**MISCELLANEOUS DETAILS FOR DRAINAGE STRUCTURES STANDARD PLAN B-30.90-02**

**SUPPLEMENTAL TO STANDARD PLAN  
B-30.90-02**

**Modify the Standard Plan as follows:**

**STEP**

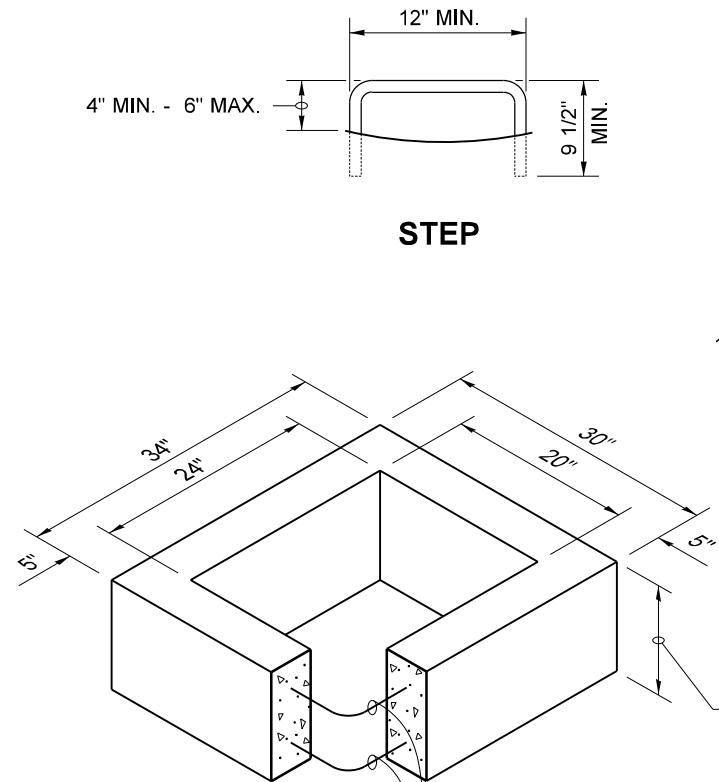
1. No steps shall be installed within concentric manhole sections.

2. Where steps are installed, they shall be polypropylene.
